Information for DOE-NRC Discussions  
NRC Request for Additional Information  
SRS Tank 19 and Tank 18 Section 3116 Draft Waste Determination

CBU-PIT-2006-00106  
June 6, 2006

### Draft 3116 Waste Determination for Closure of Tank 19 and Tank 18

For DOE-NRC Discussions Related to Performance Assessment

## Comment 4 (radionuclide removal)

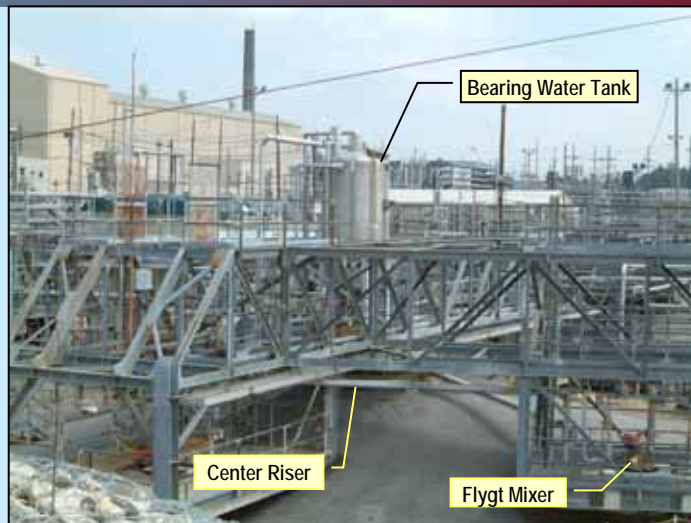
Basic path forward recommended by NRC: Provide additional information on 6 matters related to waste removal technology selection.

Proposed DOE approach: Provide the requested information with supporting details.

- Available tank risers were used to the best advantage in waste retrieval
- *Line of sight* refers to area of tank interior visible from opening without camera
- Creating new tank openings entails risk to tank structural integrity
- Tank 19 center riser plugs could not be removed due to interferences
  - However, structural evaluation was performed and it was determined to be acceptable to drill small holes in center riser plug
- Substantial personnel radiation exposure (total person-rem) would be involved with removal of equipment presently installed in Tanks 19 and 18

Photo of Tank 19 Floor Lifting Plate

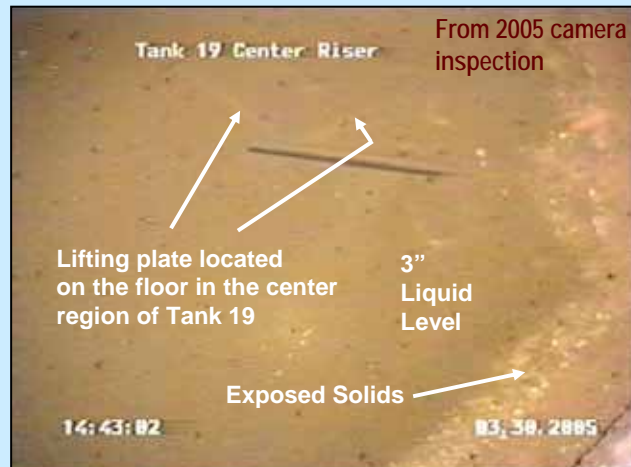
Basic path forward recommended by NRC: Provide solid sample details, including samples taken in residual hardened material in both tanks, or increase tank inventories to account for uncertainty

Proposed DOE approach: Provide information to demonstrate there are no hidden zeolite slabs in Tank 19 and that contents of both tanks are well mixed.

- Tank 19
  - (1) All zeolite discharged directly under NE riser; (2) hydrolance broke up zeolite slabs under this riser, with 11 detailed inspections showing no zeolite slabs elsewhere in tank (see next slide); (3) heel maps show significant redistribution of residual solids; (4) simulant testing showed mixer effectively cleaned tank bottom; and (5) velocity profile test results
- Tank 18
  - (1) South mound sample results were carefully considered in inventory development and (2) alternative method separately characterizing south mound material produced only negligibly different inventory (see figures)

## Comment 22 (receptor description)

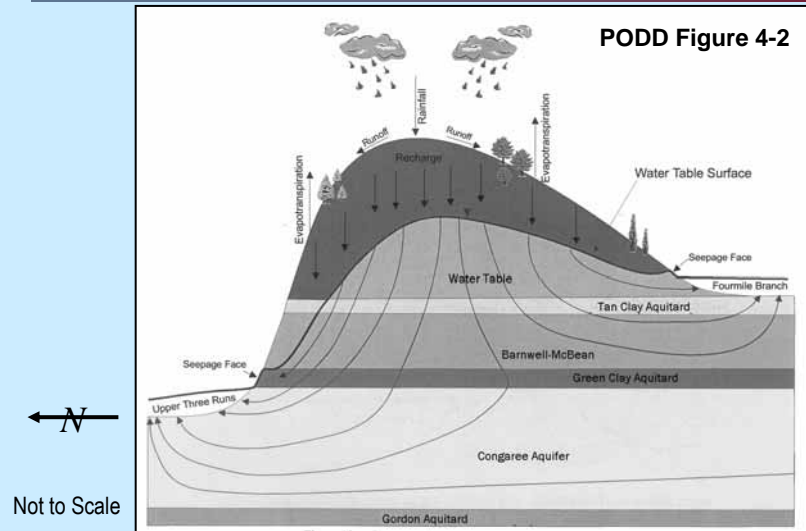
Basic path forward recommended by NRC: Provide data showing all aquifer flow discharges to the streams or demonstrate that the seepage receptor receives higher dose than would a receptor using groundwater at an offsite location, assuming underflow.

Proposed DOE approach: Provide information demonstrating that all aquifer flow discharges to the streams.

- The water table is higher on either side of Fourmile Branch, confirming no underflow
- Potentiometric data for Barnwell-McBean aquifer on both sides of stream indicate flow toward Fourmile Branch
- Groundwater flow maps from semiannual Corrective Action Reports show that Upper Three Runs and Fourmile Branch bound GSA groundwater flow (see figures)
- Large scale integrated groundwater modeling of the GSA confirms this conclusion

## Comment 23 (receptor description)

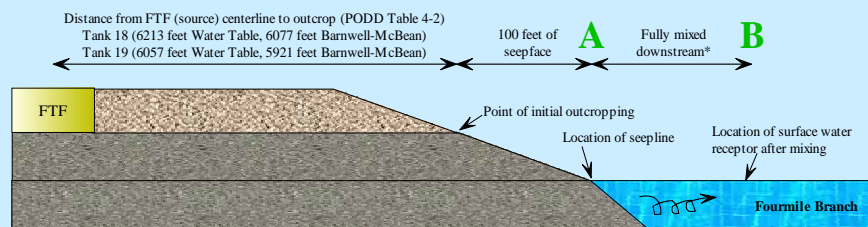
Basic path forward recommended by NRC: Clarify receptor locations, put all on a single map, provide additional details.

Proposed DOE approach: Provide requested information, including revised PODD Figures 4-3 and 4-7; provide new figure showing all receptor locations; and a new table with pathway details.

- The public receptor for soil ingestion is located at the shoreline at the downstream point of maximum surface water exposure, rather than at the seepage line
- The public receptor for direct radiation is located at the shoreline at the downstream point of maximum surface water exposure

PODD Figure 2-7

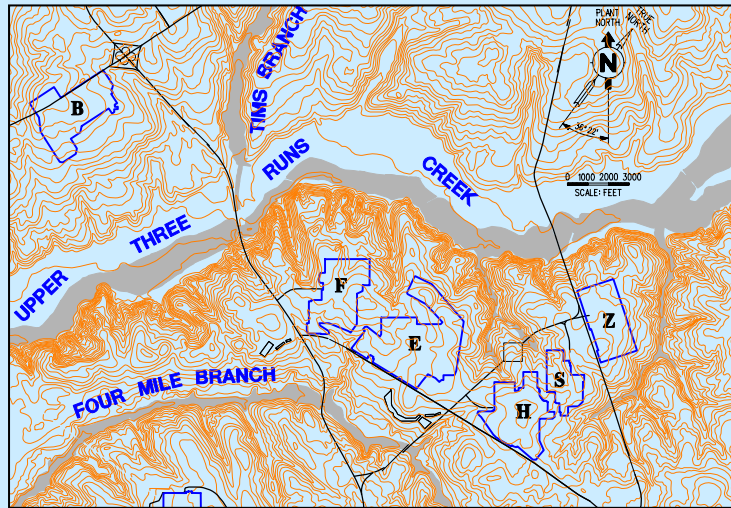
## Comment 24 –stream location

## Comment 25 (receptor description)

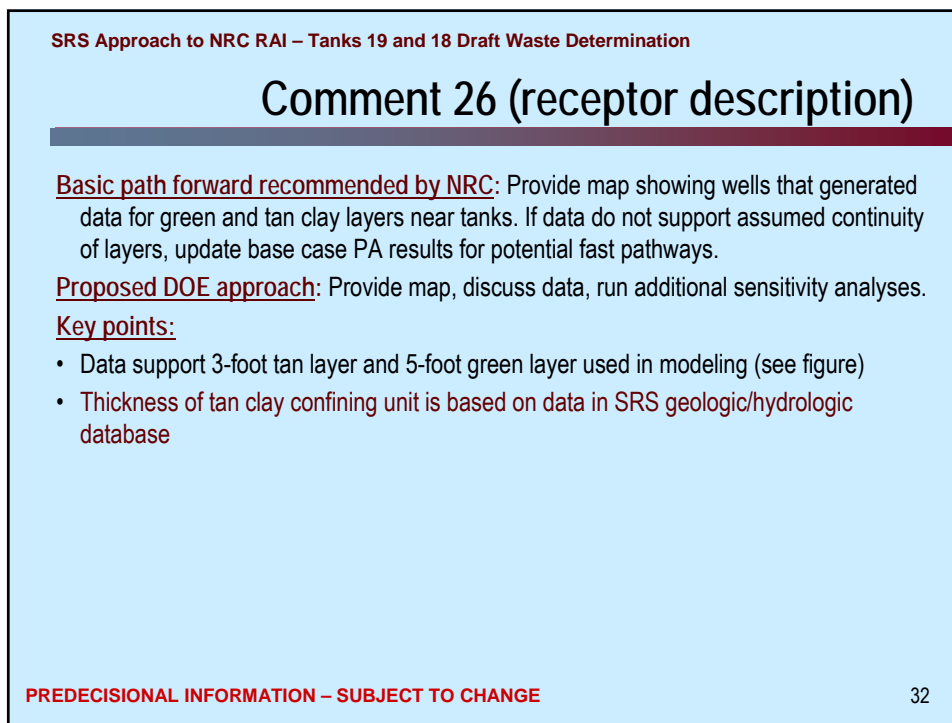
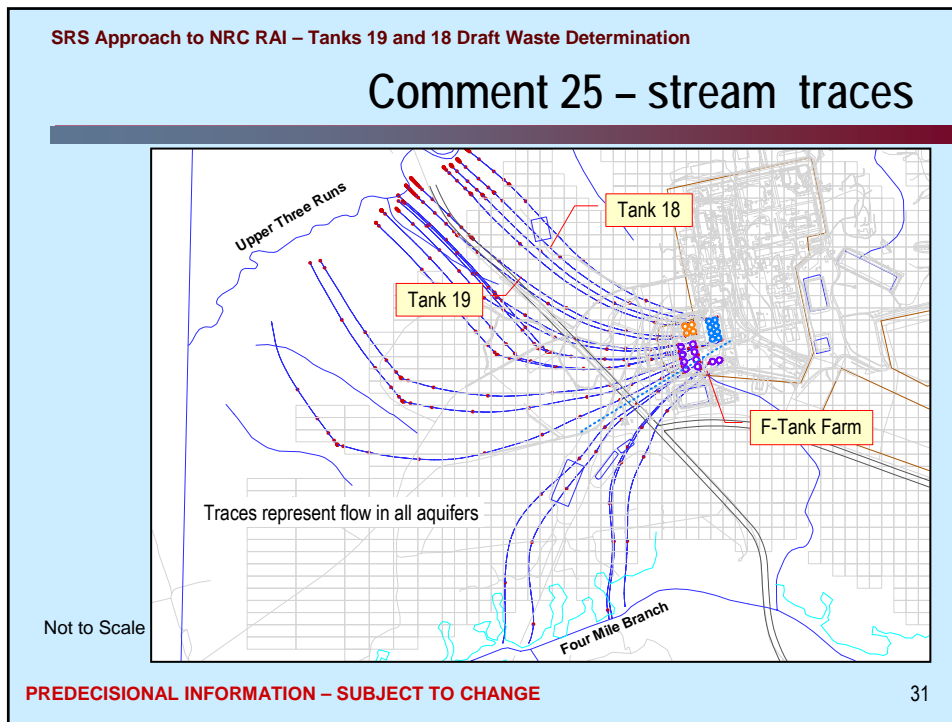
Basic path forward recommended by NRC: Provide information about relative amounts of contaminated infiltration water that flow toward Fourmile Branch and Upper Three runs for each aquifer.

Proposed DOE approach: Provide requested information (see also Comment 21).

- Stream tracer runs based on GSA groundwater flow model (see figure) show that leakage from Tanks 19 and 18 will move toward Upper Three Runs
- 31%/65%/4% balance in Q-CLC-H-00005 based on calibrated model and area closest to the groundwater flow path to Fourmile Branch
- Modeling groundwater flow toward Fourmile Branch is conservative
  - Modeling flow toward Fourmile Branch effectively concentrates contaminants in the upper aquifers, making higher concentrations available for seepage exposures
  - Lower Fourmile Branch flow rate (<10% of Upper Three Runs) means less dilution (and more conservatism) in Fourmile Branch model
  - Permits modeling all 22 FTF tanks on single centerline to Fourmile Branch

Map Showing Wells Close to Tanks

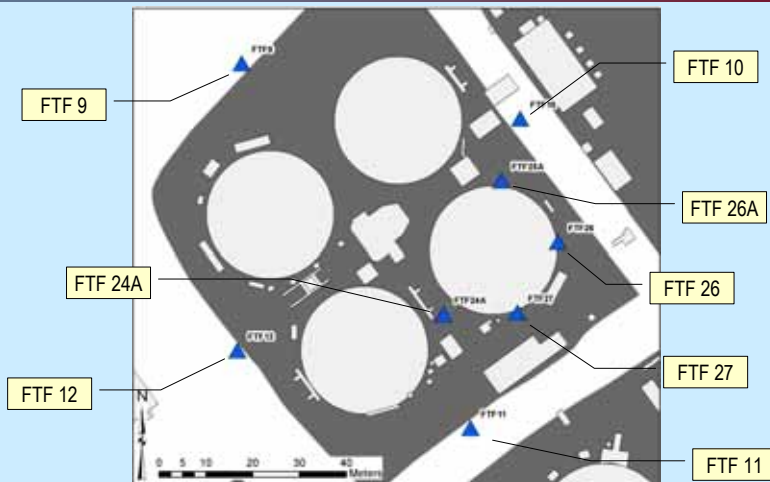
Basic path forward recommended by NRC: Provide all F-Tank Farm water level data and other information on water table depth at tanks. Assess impacts with tank bottoms in water table to inadvertent intruder and member of the public.

- New map shows wells close to tanks (see figure)
- Well data being provided includes up to year 2000
- Historical data show long-term average below base case of 224 feet above mean seal level
- NUREG-1573 indicates that long-term climate changes not to be considered
- Additional sensitivity analyses are being performed
  - Results are to be provided
- Statistical projection was not developed because sensitivity analyses will bound potential conditions

## Comment 46 (near field release)

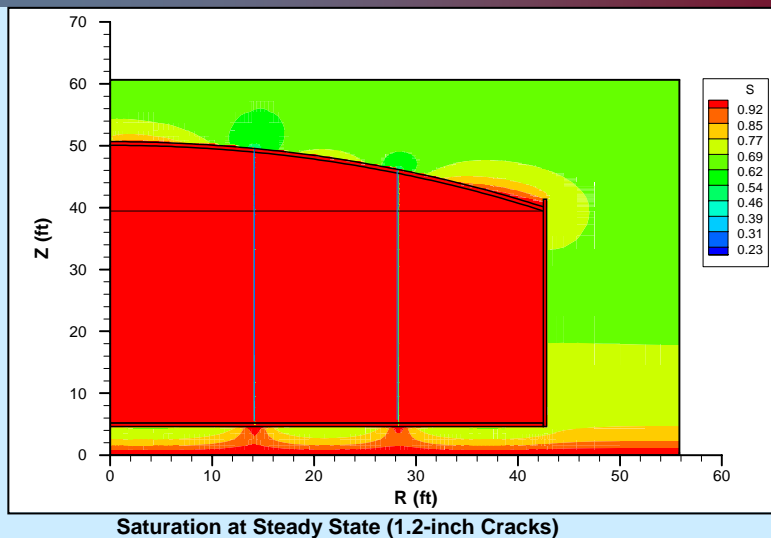
Basic path forward recommended by NRC: Provide basis for assumption that cracks in grout would remain saturated or update extent of oxidation. Provide basis for estimating or bounding impact of grout oxidation on Tc-99 release during 10,000 year period.

- In model associated with PODD Figure 2-35, simulated annular cracks were actually unsaturated (note blue lines in figure)
- Transport model considered only liquid-phase oxygen transport, under-predicting oxygen concentrations, but this model is appropriate because oxygen concentration at grout boundaries would be at saturation for practical purposes
  - Liquid phase diffusion within grout dominates, so including gas phase would not significantly alter slag reduction capacity
- Over time, grout will become saturated by drawing water from surrounding soil

## Comment 48 (near field release)

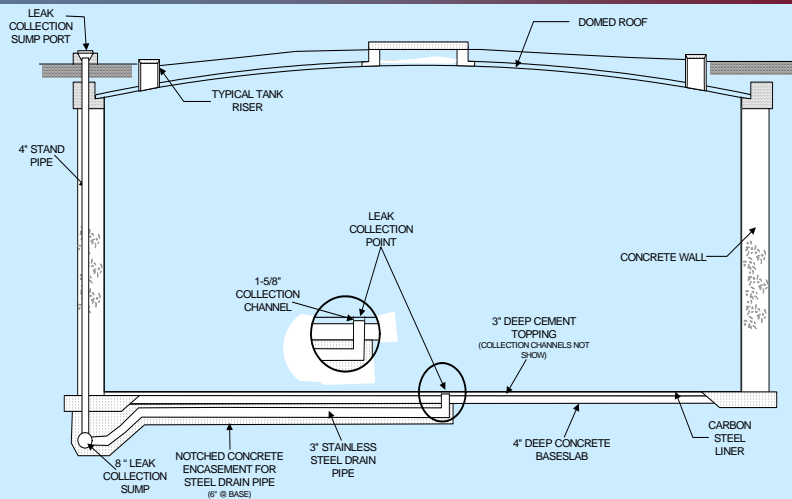
**Basic path forward recommended by NRC:** Provide data to show basemats are intact, or assess impact of current cracks on public and intruder doses. Provide basemat design details, describing expected effects of drainage slots on basemats.

**Proposed DOE approach:** Provide requested information.

- Sensitivity study to evaluate impacts of 4-inch basemat and no basemat in progress
  - Results bound drainage channel condition and potential fast flow paths
- Basemat foundation and floor were constructed of Class C concrete poured without construction joints (all other design details being provided)
- Concrete testing was performed in accordance with DuPont specification (information being provided)
- Settlement survey data from 1991-2001 showed <1/4-inch settlement/heave for tanks
  - Survey report notes results “do not indicate any significant trends or distress”

## Comment 50 (far field release)

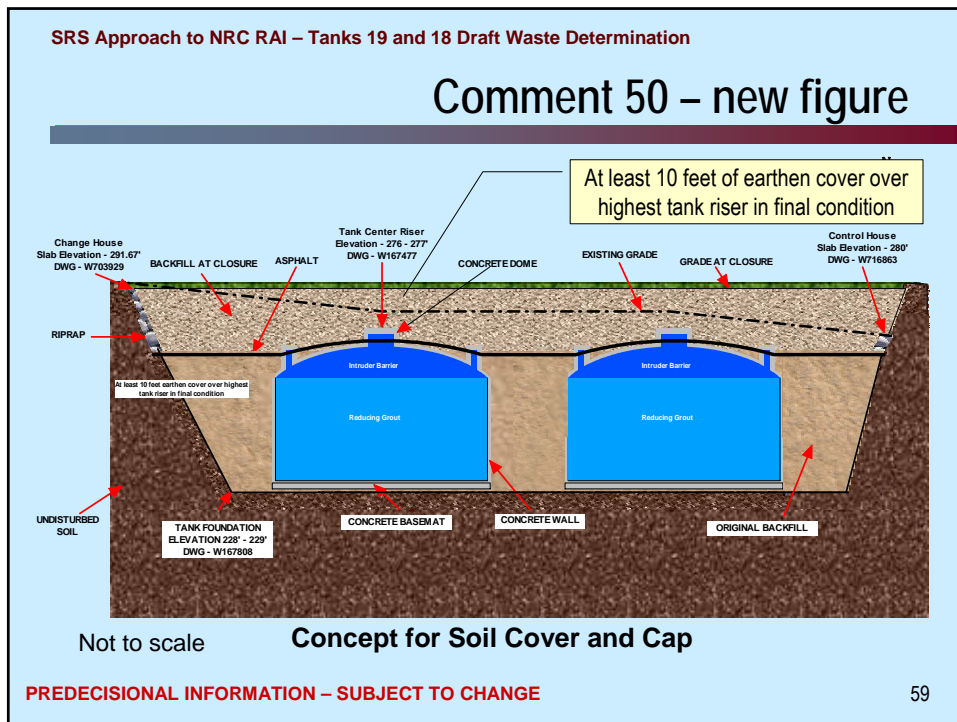
Basic path forward recommended by NRC: Provide basis for (1) hydraulic conductivity of disturbed soil being the same as for undisturbed soil and (2) that riprap layers will not result in high long-term infiltration to the tanks.

- Soil of interest under tank was undisturbed until basemat and wall foundation were poured; therefore, use of undisturbed values is reasonable
- The riprap and disturbed soil around and above the tank are not associated with MEPAS soil input parameters
  - Significant conservatism comes from ignoring the effect of the earthen cover and low-permeability barrier on infiltration rate
- The sensitivity study on the 40 cm/yr infiltration rate will show the effect of doubling the infiltration rate on peak Tc-99 dose for both tanks
  - Bounds possible effect of riprap channeling flow toward tanks

### Comment 51 (model implementation)

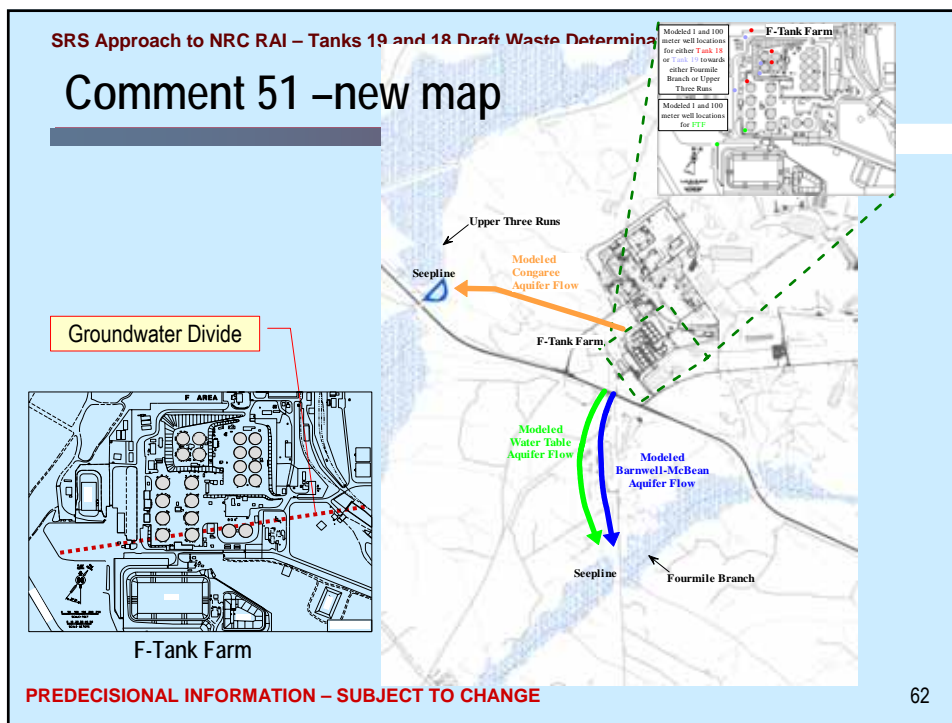
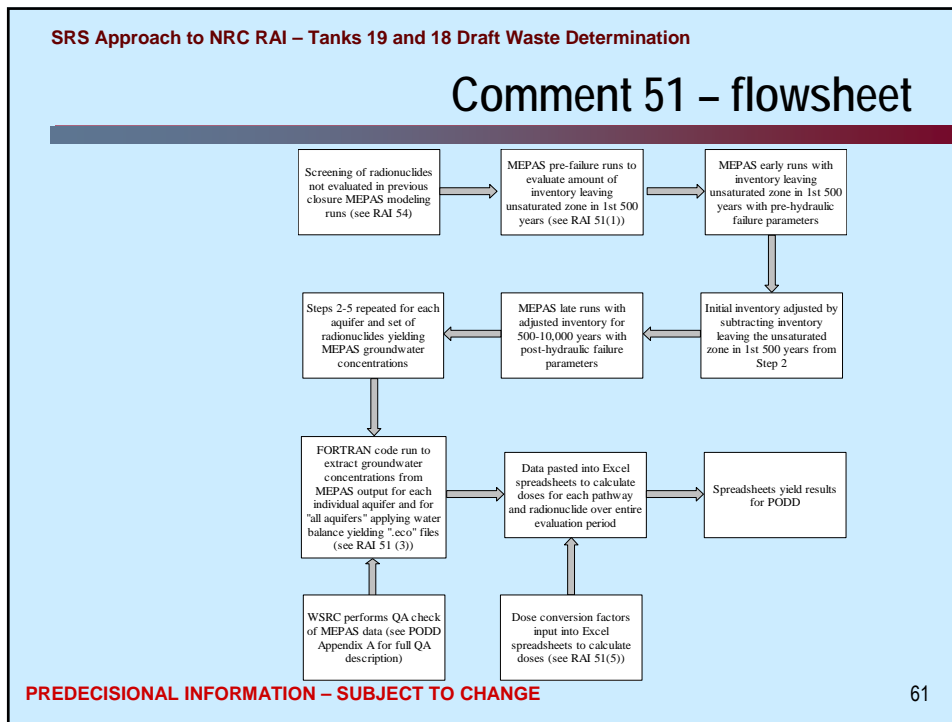
**Basic path forward recommended by NRC:** Provide detailed information to clarify the overall computational approach, provide MEPAS files for dose conversion factor calculations, and provide a map with all receptor locations and other details.

- All of the requested information is being provided, including addressing each of the 7 areas listed in the Comment BASIS:
  - 1) MEPAS calculation mechanics, including why code was run 3 times
  - 2) Algorithm used in early MEPAS runs
  - 3) FORTRAN program functions
  - 4) How aquifer water balance percentages were included
  - 5) How pathway dose conversion factors were calculated
  - 6) Pathways included in and excluded from Table 4-15 thru 4-35 calculations
  - 7) Distances used from tanks to seepage receptor
